Harpurhey Community Diagnostics Centre, Wavertree – Addendum Technical Note

April 2024

MCC Comments and SLR Response

DRAWING NUMBER:
432.002796.00001 - D100

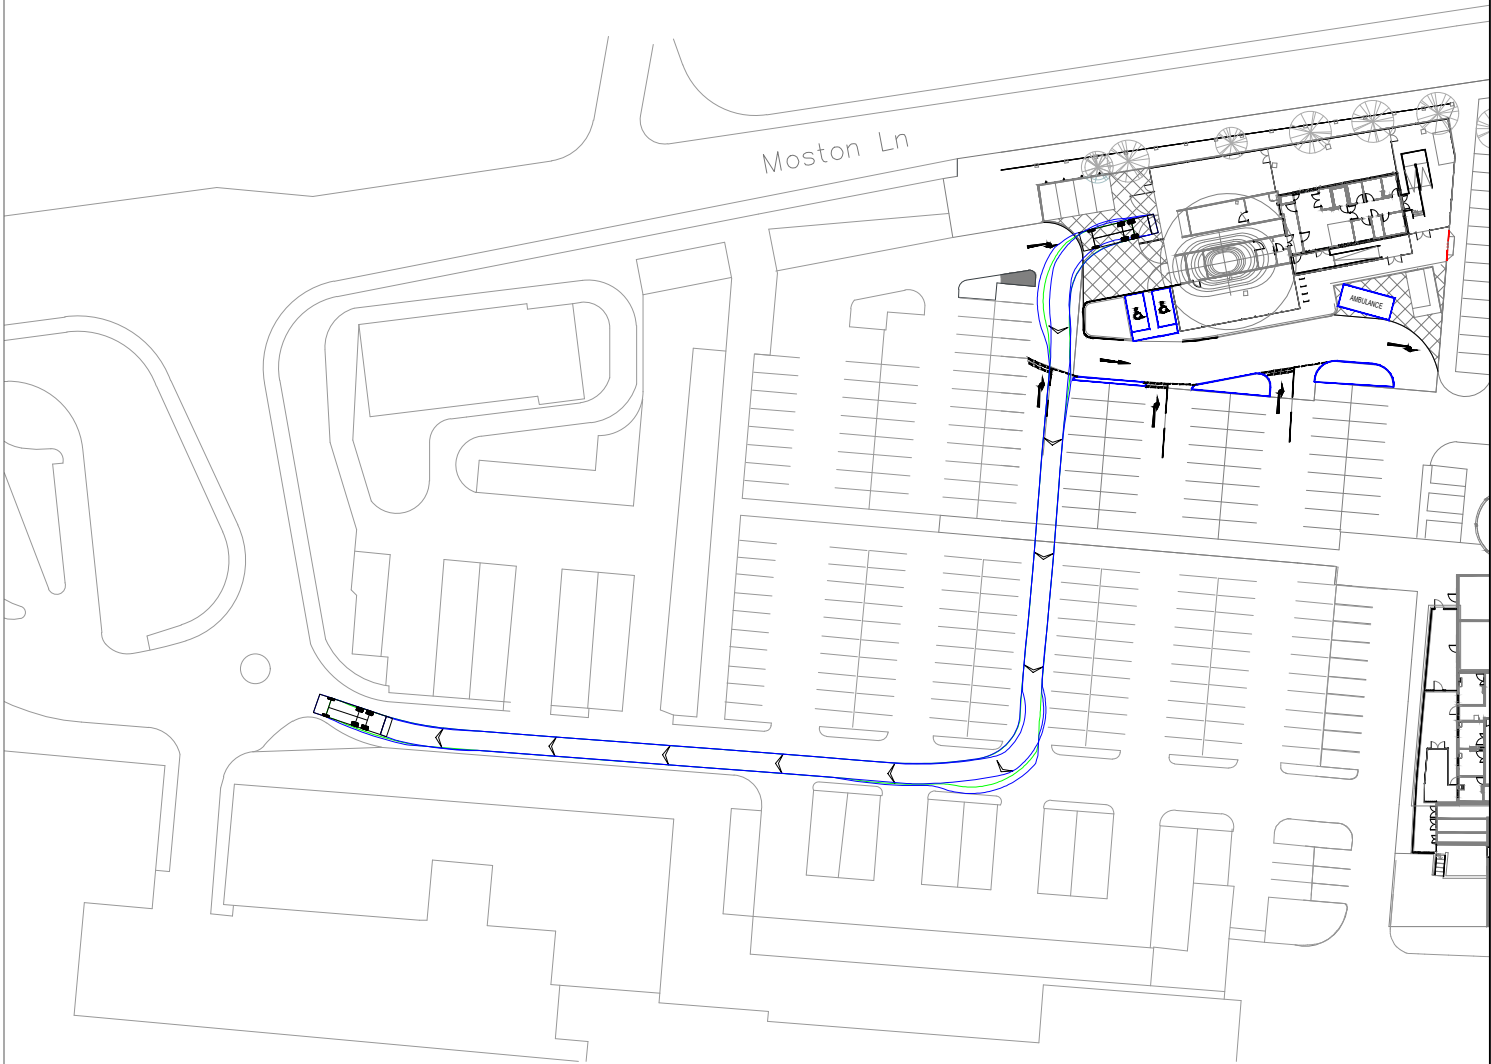
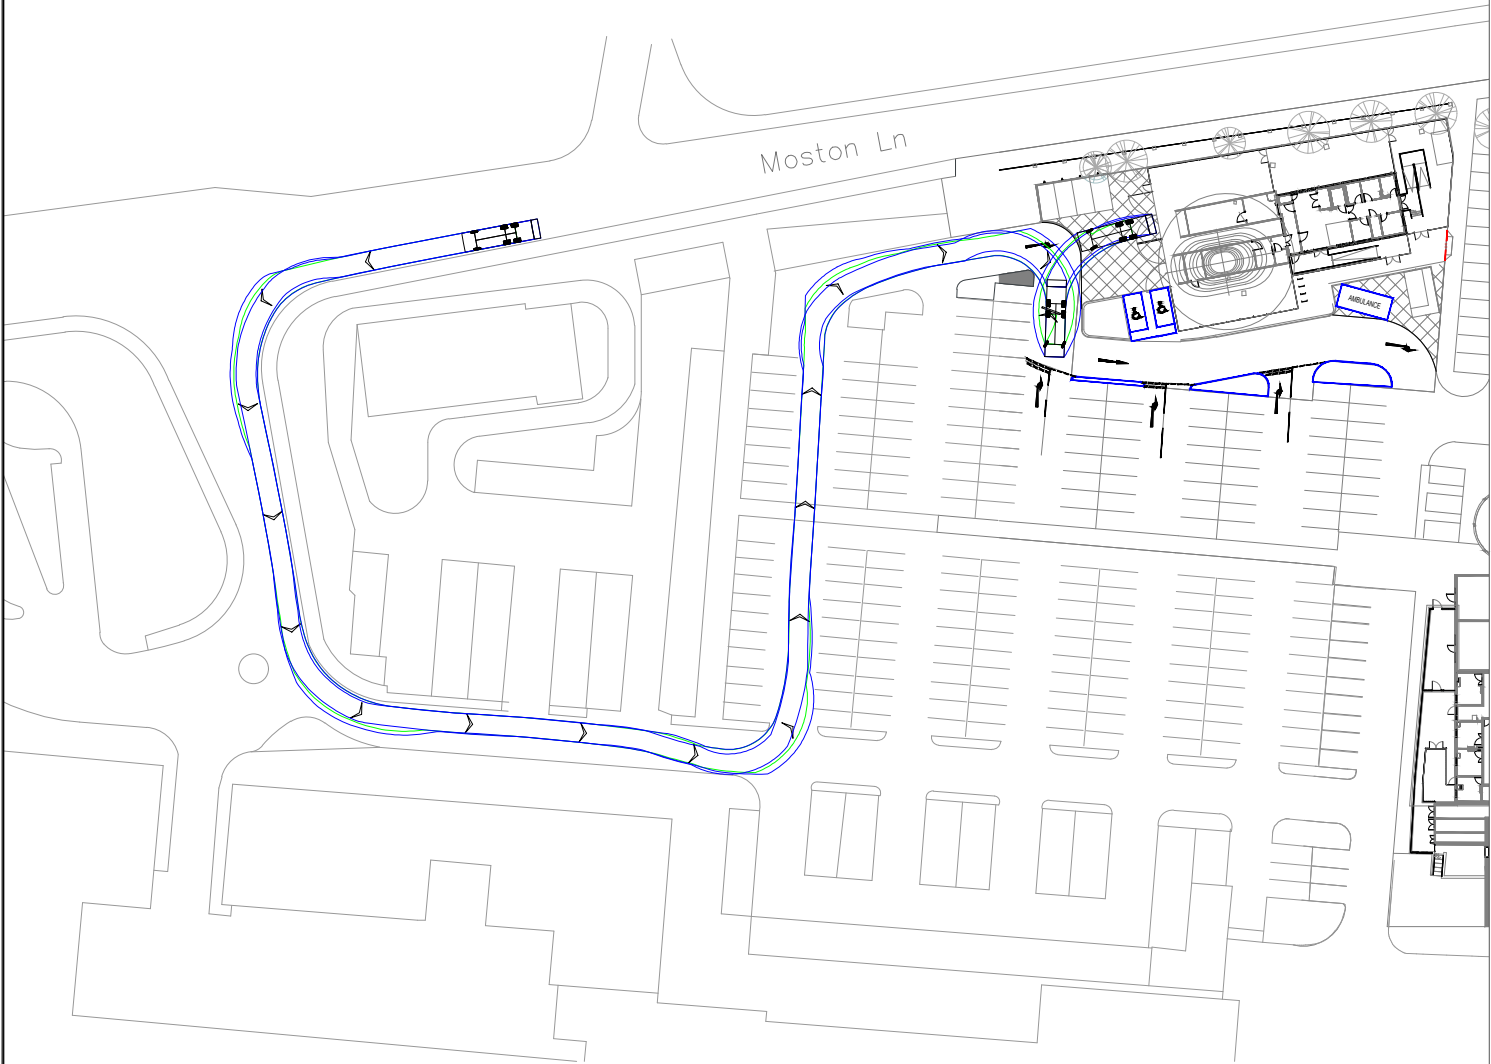
The applicant should confirm that all proposed (and any reconfigured) car parking bays are demarcated in alignment with MCC standards (min. 2.4m x 4.8m) with additional 1.2m side and rear clearance for disabled bays. Plans should also be updated to show full car-park reconfiguration markings and further detail regarding remaining aisle widths to ensure safe and efficient car-park operations in the vicinity of the works.

These details are shown on **Drawing 432.002796.00001 D100 Rev B**. It is proposed that the two disabled bays together will comprise of a shared side access zone and there will be a gap in the proposed bollards to facilitate vehicular access and egress.

DRAWING NUMBER: 432.002796.00001 - TR101

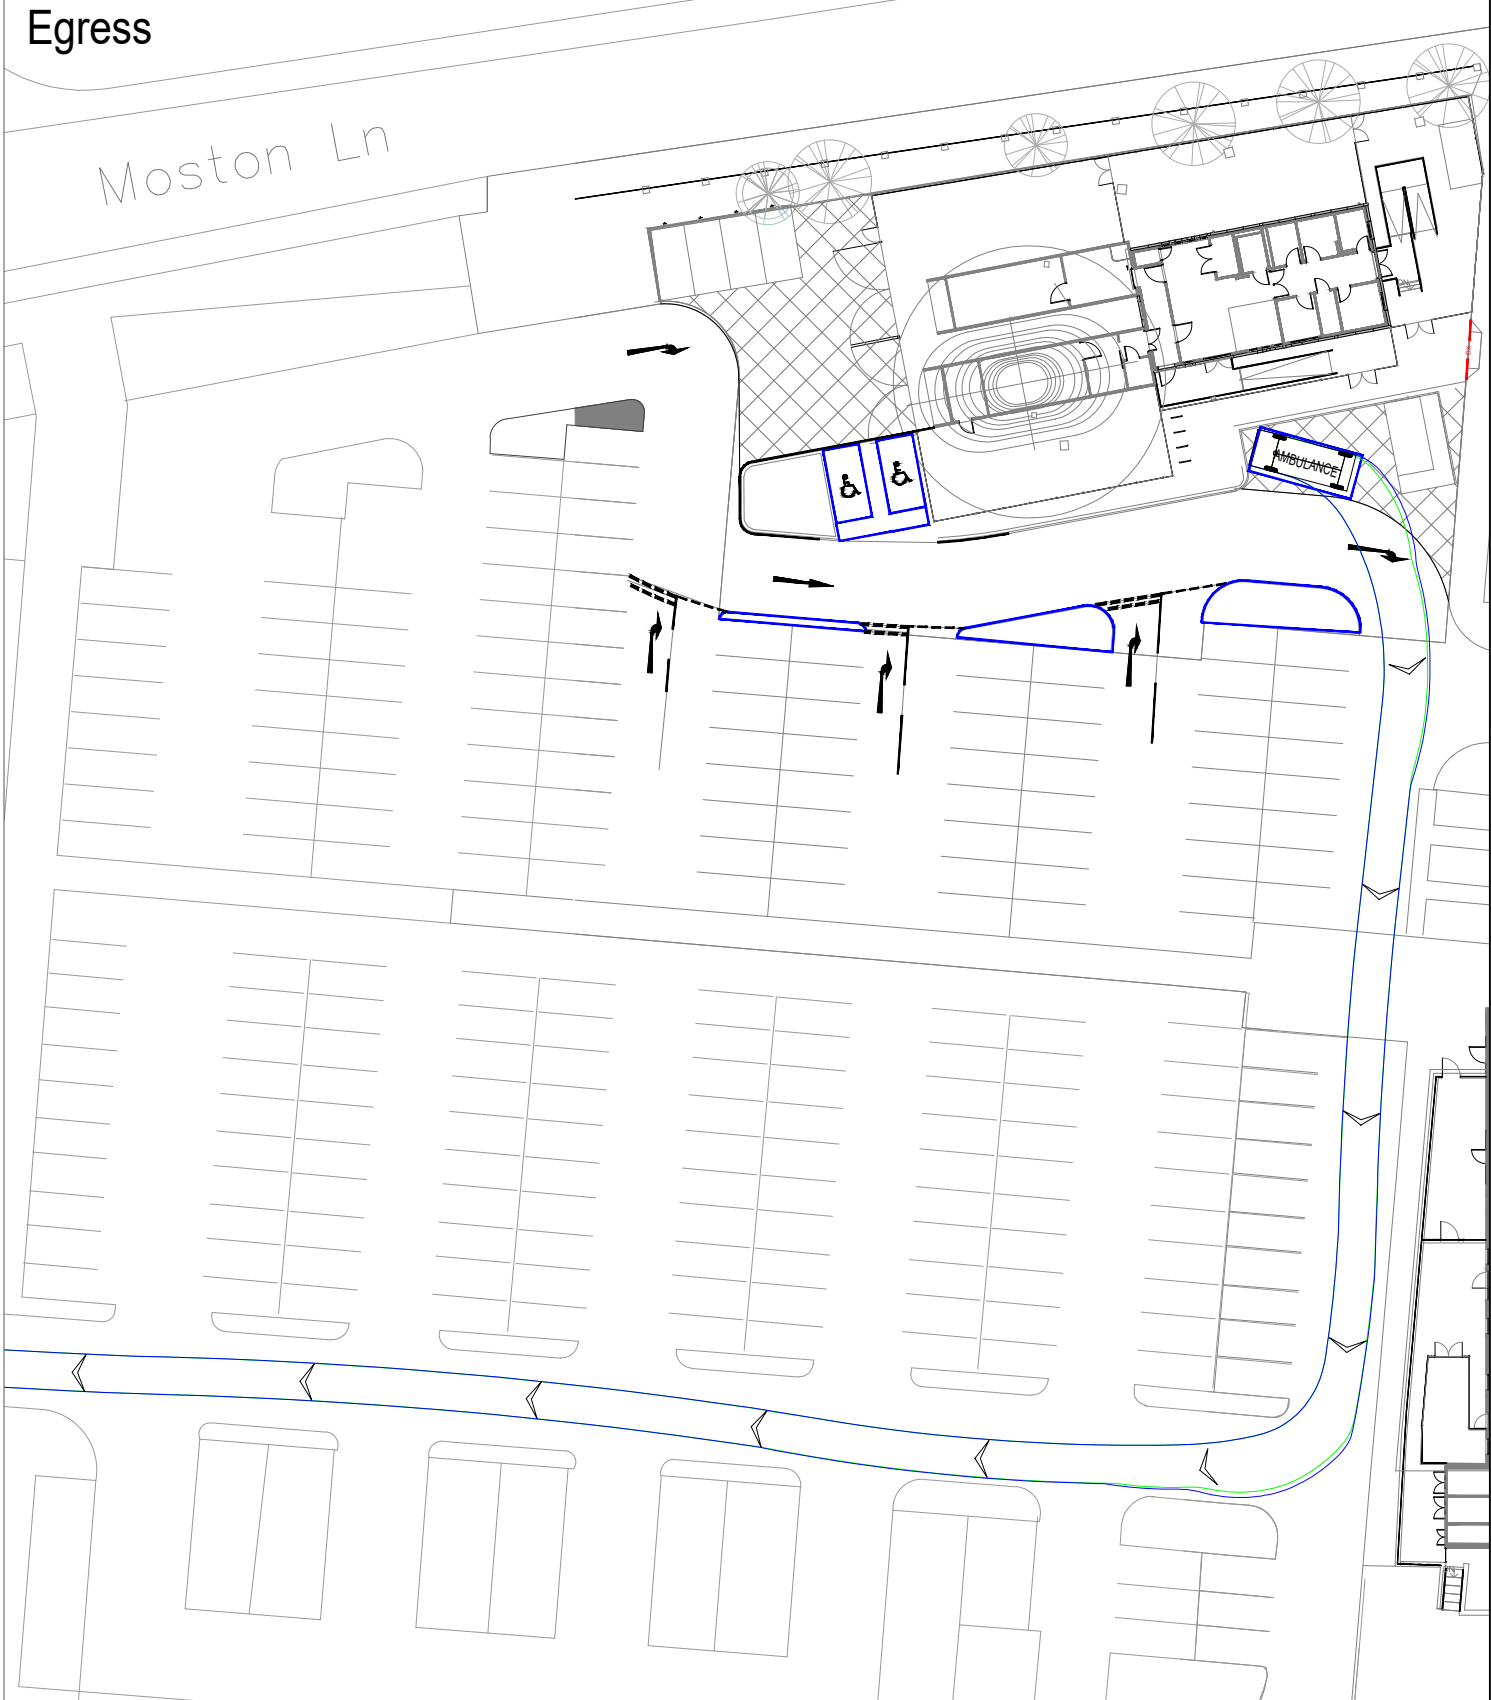
Highways request that the proposed Ambulance bay is subject to swept-path assessment.

The swept path analysis of the ambulance bay is shown in **Drawing 432.002796.00001 TR101 Rev A**.

SCALE						FIRST ISSUED	
As indicated @ A1						09/05/23	
PROJECT		CLIENT REF		DRAWN BY		CHECKED BY	
23051		-		Author		Checker	
ORIGIN	VOLUME	LEVEL	TYPE	ROLE	NUMBER	REVISION	
DAY	HARXXX	XX	DR	A	07-0101	D	
SUITABILITY							
Planning

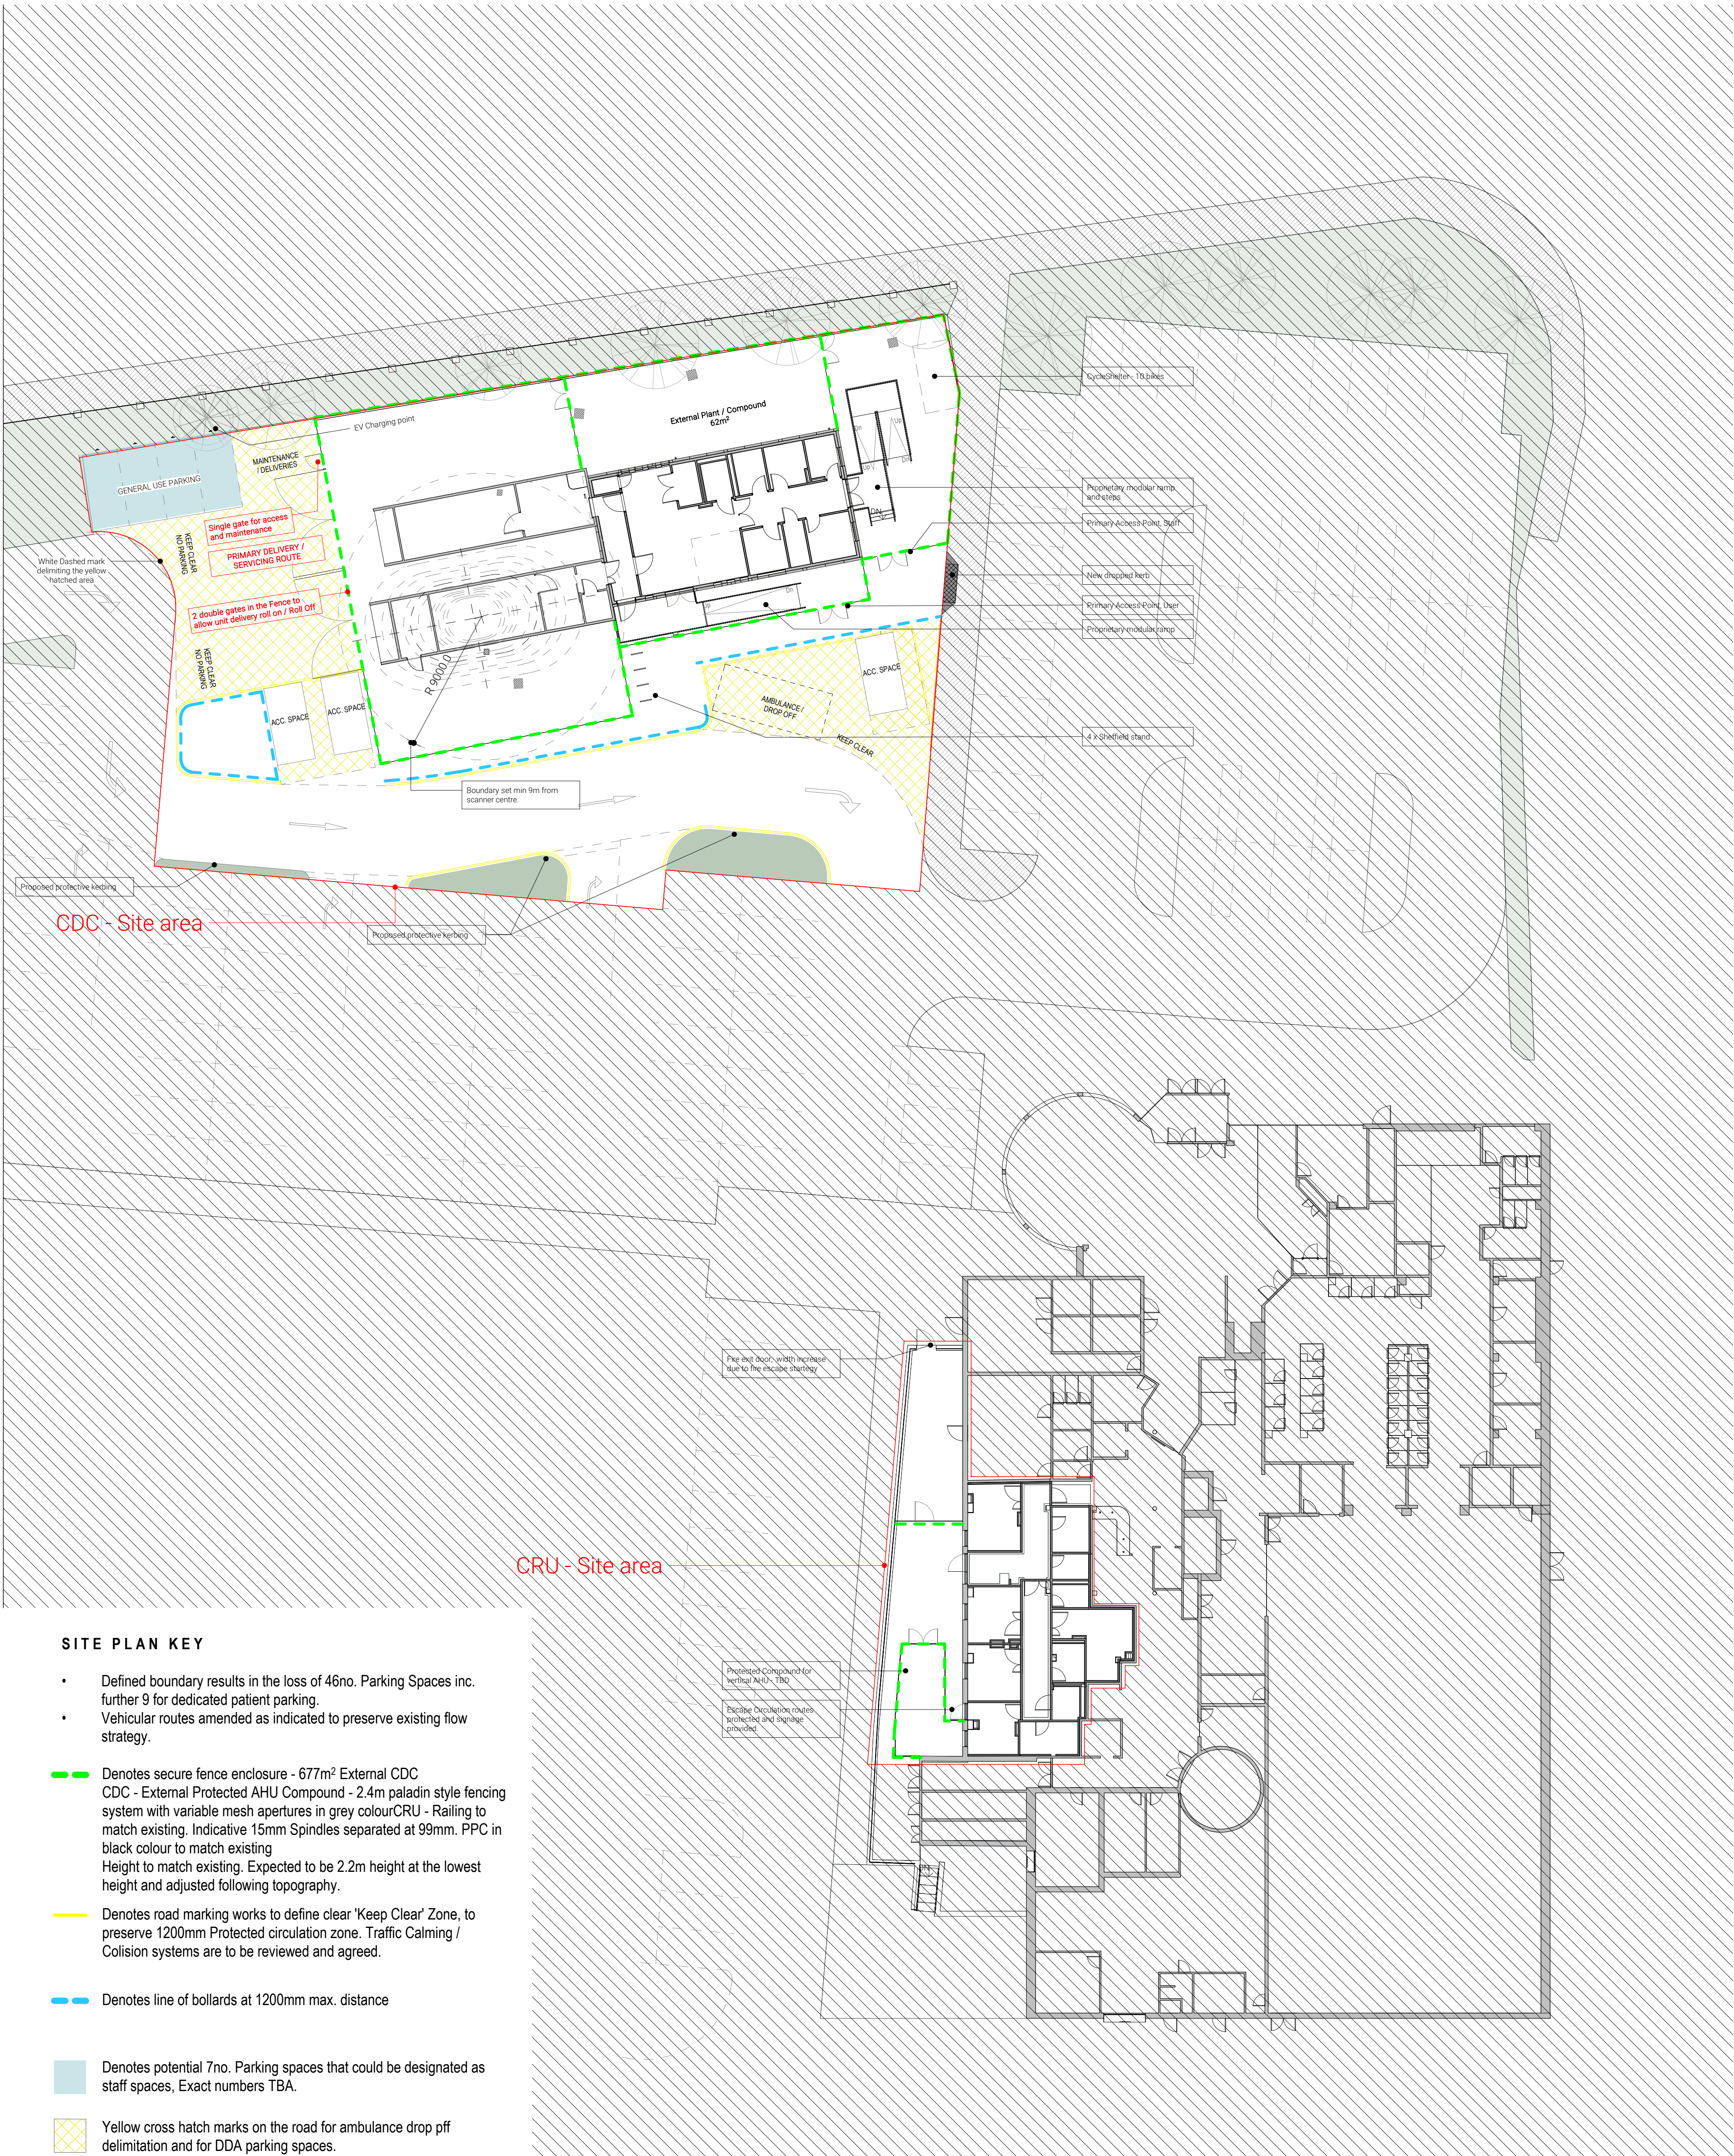
The TS states that 5no. (staff) car parking spaces are proposed together with 3no. disabled bays and ambulance drop-off bay. Submitted plans however only appear to show 4no. standard parking bays rather than 5no. (As shown in Drawing DR-A-07-0101-Rev C). Clarification is required.

It is noted that the existing North City Family & Fitness Centre has 13no. covered Sheffield Stands (i.e. 26 cycle parking spaces) located adjacent to the main building entrance. The TS states that such provision is currently highly underutilised with ample spare capacity. Since the CRU testing facility is a refurbishment of this existing building, the TS suggests that the existing cycle parking provision is deemed appropriate for the CRU. Highways request however that some secure provision is provided for staff use.

The proposed site layout comprises of four parking spaces, as shown in **Appendix B**.

The revised cycle parking provision is shown on the attached proposed site plan in **Appendix B**, and this includes four Sheffield stands (eight spaces) for patient / visitor use to the south of the CDC building and a cycle shelter (secure and covered) to the northeast of the CDC with five stands (10 spaces). These cycle parking facilities will be available for users of the CRU testing facility in addition to 13no. covered Sheffield stands that are located adjacent to the North City Family & Fitness Centre main building entrance, and it is considered that this overall level of cycle parking provision is appropriate to serve the proposed development.
